**ADDISON AIRPORT  
BUILDING REPORT**

**Facility Information:** **Facility Name:** Cavanaugh Flight Museum - Main Building  
**Facility Contact:** Lisa Pyles **Contact Phone:** 972-450-2878

**Accessology Inspector Information:**  
**Inspector:** Karen Jackson **Date:** April 17, 2017  
**Email:** Kjackson@accessology.com

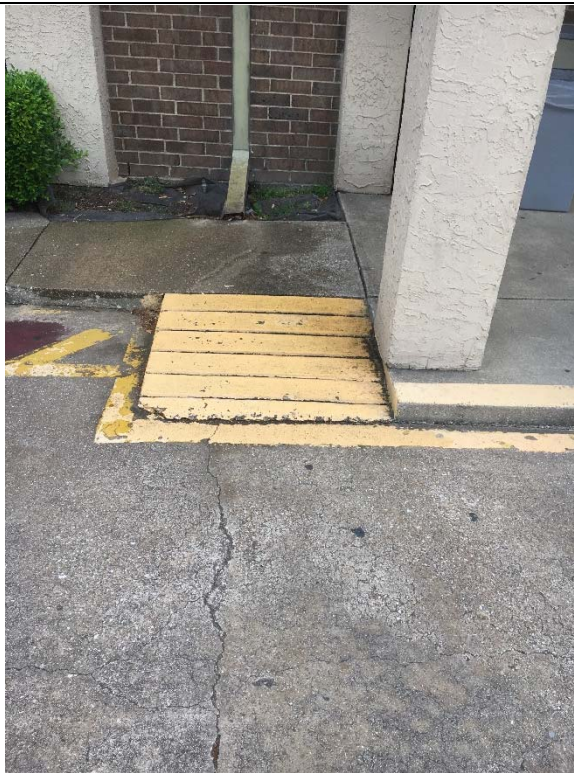
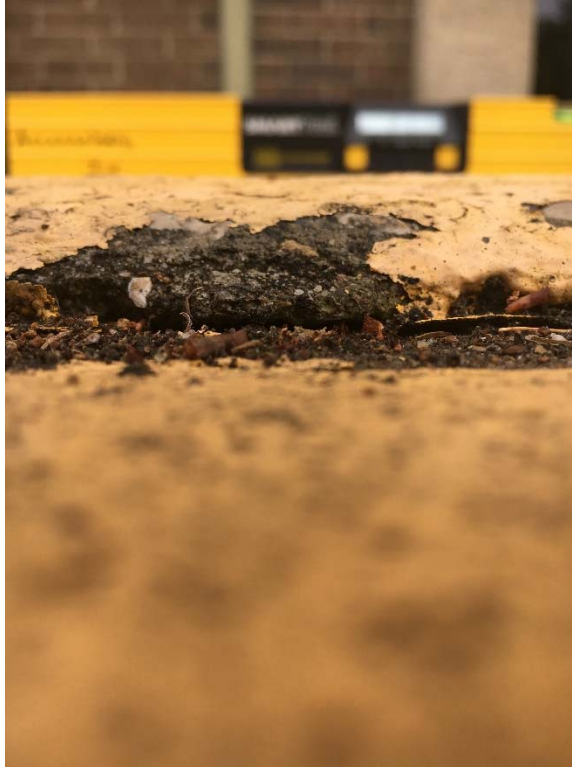
**Violation #1:** The access aisle is only 53" wide, where it is required to be a minimum of 60" wide.

The accessible parking space is required to van accessible.

The expansion joint that runs from the parking space through the access aisle has grass growing up through it.

The parking sign is faded and illegible.

**Violation 1** - The access aisle is only 53" wide, where it is required to be a minimum of 60" wide.

**Violation 2** - The accessible parking space is required to van accessible.

**Violation 3** - The expansion joint that runs from the parking space through the access aisle has grass growing up through it.

**Violation 4** - The parking sign is faded and illegible.

Restripe access aisle.

Restripe accessible parking space and access aisle so the accessible space and access aisles are each a minimum of 96" wide. Price included with Violation #1.

Clean out and caulk the expansion joint to achieve a smooth transition.

Replace with a compliant van accessible sign.

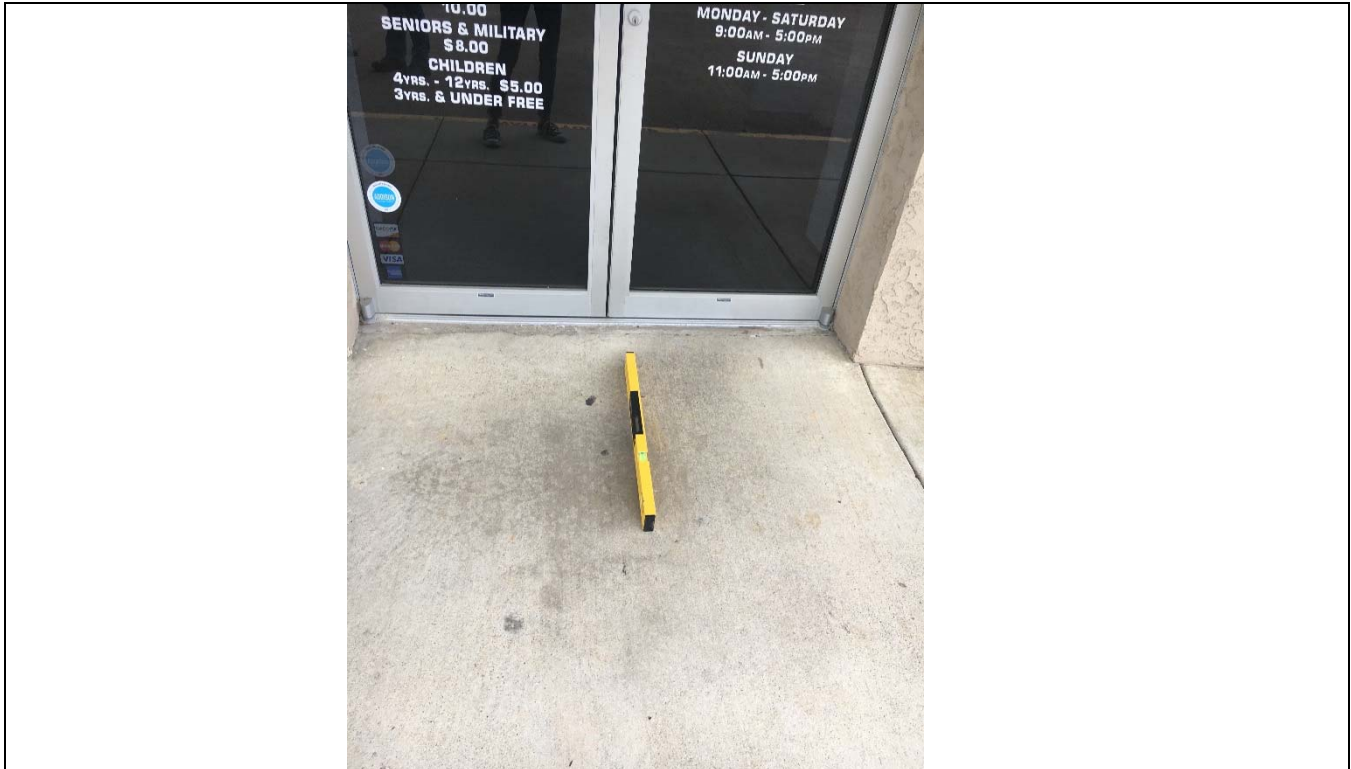
**Violation #5:** The sidewalk as well as the landing at the top of the curb ramp has a 5.4% cross slope.

**Violation #6:** The curb ramp has a change in level greater than a 1/2" at the bottom and is 35-3/4" wide and has a drop off.

**Violation 5** - The sidewalk as well as the landing at the top of the curb ramp has a 5.4% cross slope.

**Violation 6** - The curb ramp has a change in level greater than a 1/2" at the bottom and is 35-3/4" wide and has a drop off.

**Possible Solutions:** Replace the sidewalk to achieve a cross slope no greater than 1:48.

Install new compliant curb ramp at the end of the sidewalk next to the access aisle to provide a

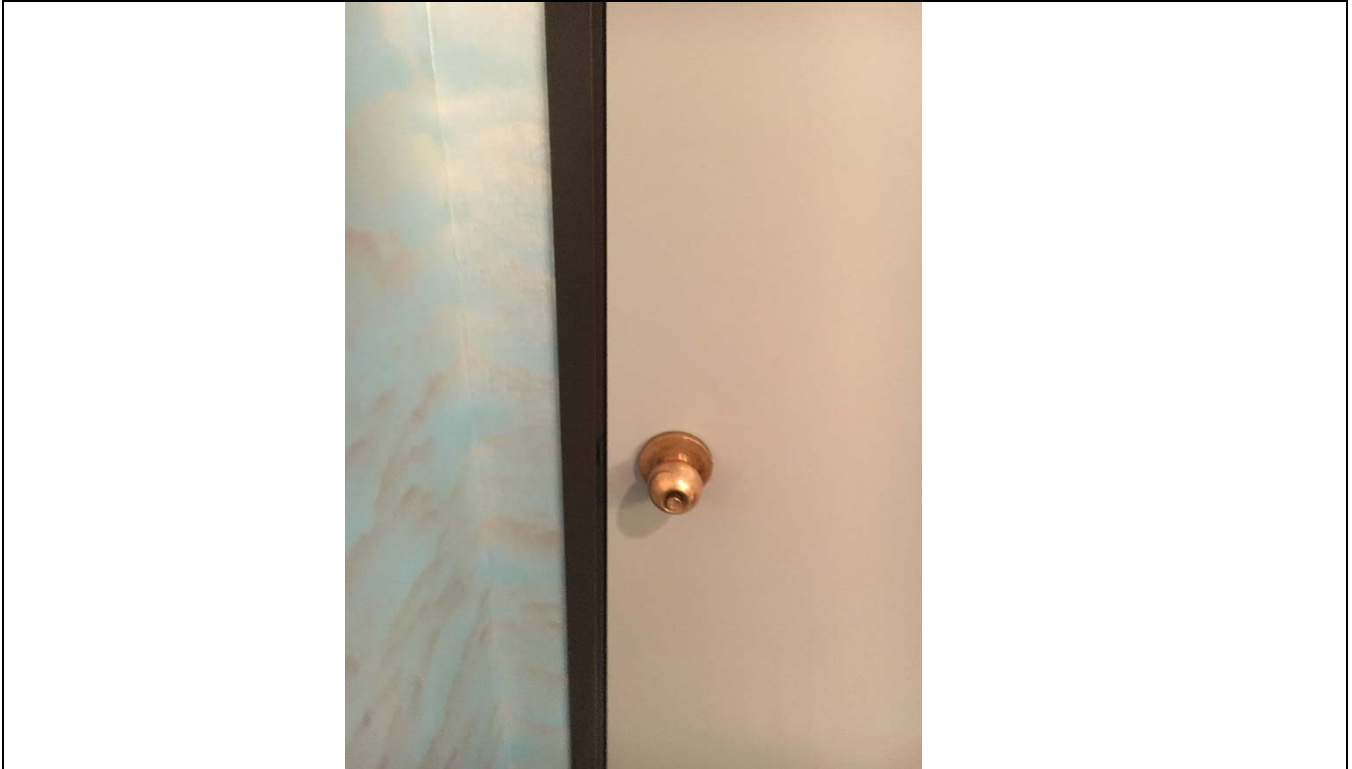
**Violation #7:** There is a 10.2% slope at the main entrance door.

**Violation #8:** The entrance door opening is only 27" wide where a minimum of 32" is required.

**Violation 7** - There is a 10.2% slope at the main entrance door.

**Violation 8** - The entrance door opening is only 27" wide where a minimum of 32" is required.

**Possible Solutions:** Remove and re-pour concrete to achieve slopes no greater than 1:48.

Modify doors so one of the door openings is a minimum of 32" opening.

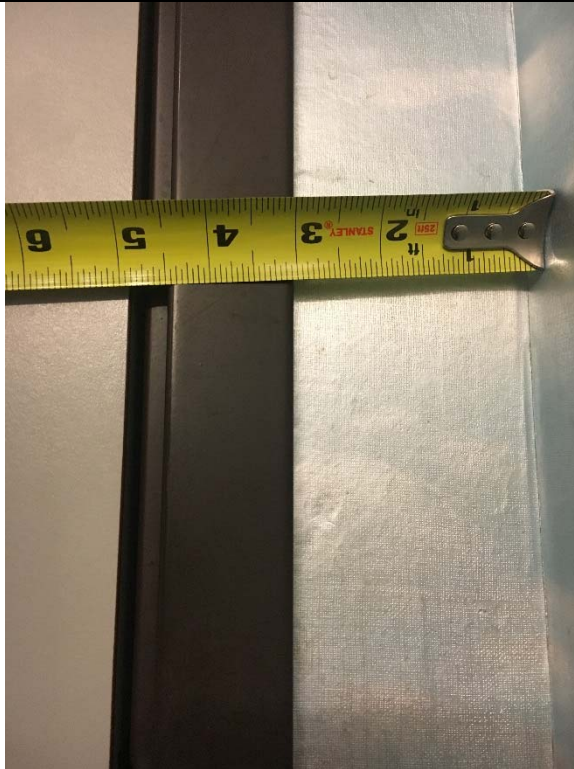
The front desk is 39-9/16" to the top of the counter.

**Violation #10:** There are four (4) doors in the facility that have knob door hardware.

**Violation 9** - The front desk is 39-9/16" to the top of the counter.

**Violation 10** - There are four (4) doors in the facility that have knob door hardware.

Replace desk or lower a portion of the desk to 36" above finished floor.

**Possible Solutions:** Replace hardware with lever hardware.

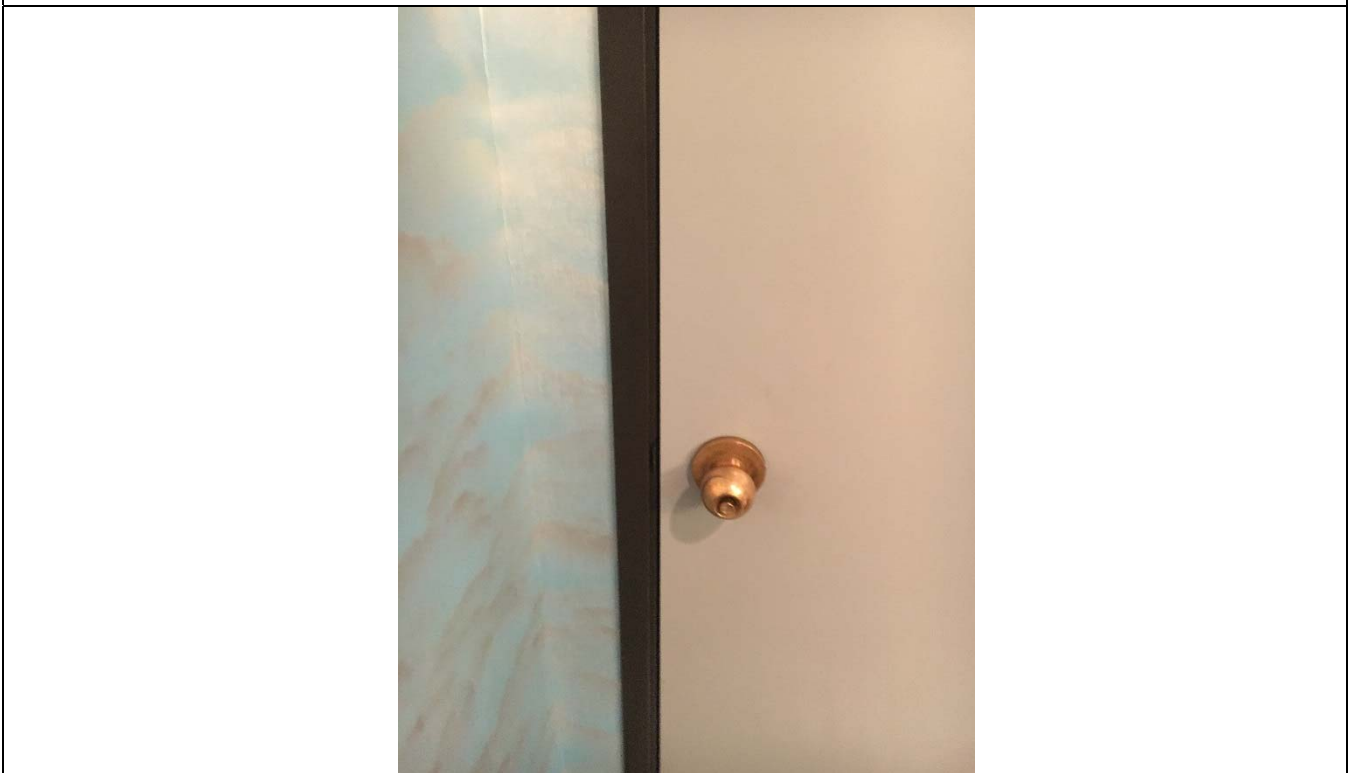
**Violation 11** - Men's Room: Signage is mounted on the door and does not have Braille or tactile characters.

**Violation 12 - Men's Room:** There is only a 4-1/2" maneuvering clearance on the pull side of the door where a minimum of 18" is required.

**Violation 13** - Men's Room: Water closet's required clear floor width is blocked by the urinal screen and the urinal.

**Violation 14** - Men's Room: Only a side grab bar is provided where both side and rear grab bars are required to be provided.

**Violation 15 - Men's Room:** The lavatory does not have the required knee clearance provided.

**Violation 16 - Men's Room:** The lavatory faucets controls require grasping and twisting to operate.

Install compliant signage on the wall on the latch side of the door.

Reverse the swing of the door.

Remove urinal and urinal screen to provide required clearances.

Install compliant grab bars at rear and side of water closet.

Modify or replace lavatory.

Replace with lever style hardware.

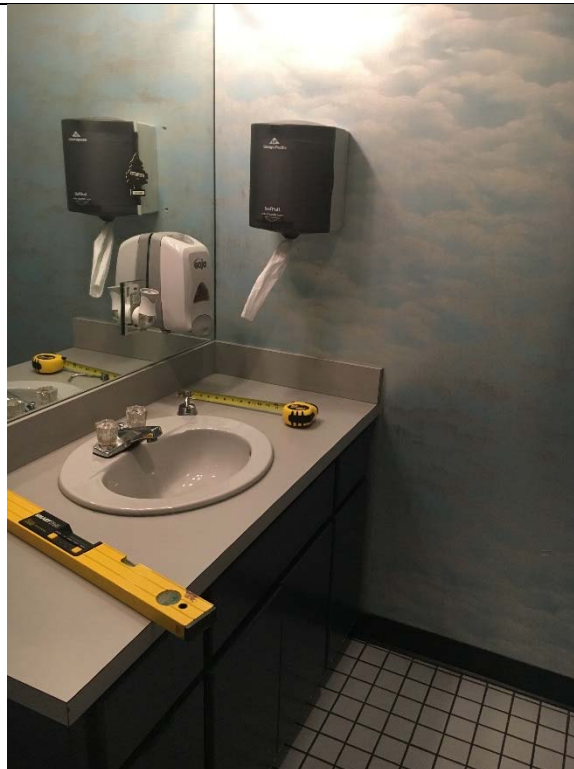
**Violation 17** - Women's Room: Signage is mounted on the door.

**Violation 18** - Women's Room: There is not a minimum of 18" provided on the pull side of the door.

**Violation 19** - Women's Room: The lavatory encroaches on the required clear floor space width for the water closet.

**Violation 20** - Women's Room: Flush control is on the closed side of the water closet.

Install compliant signage on the wall on the latch side of the door.

Reverse the swing of the door.

Reconfigure room to provide the required clear floor space for the water closet.

Replace flush valve to the open side.

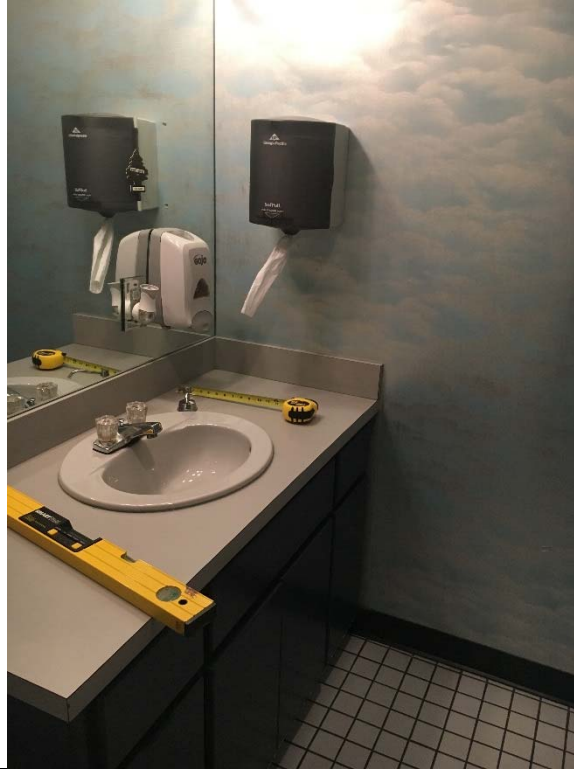
**Violation 21 - Women's Room:** Only a side grab bar is provided where both side and rear grab bars are required to be provided.

**Violation 22 - Women's Room:** The lavatory does not have the required knee clearance provided.

Install compliant grab bars at rear and side of water closet.

Modify or replace lavatory.
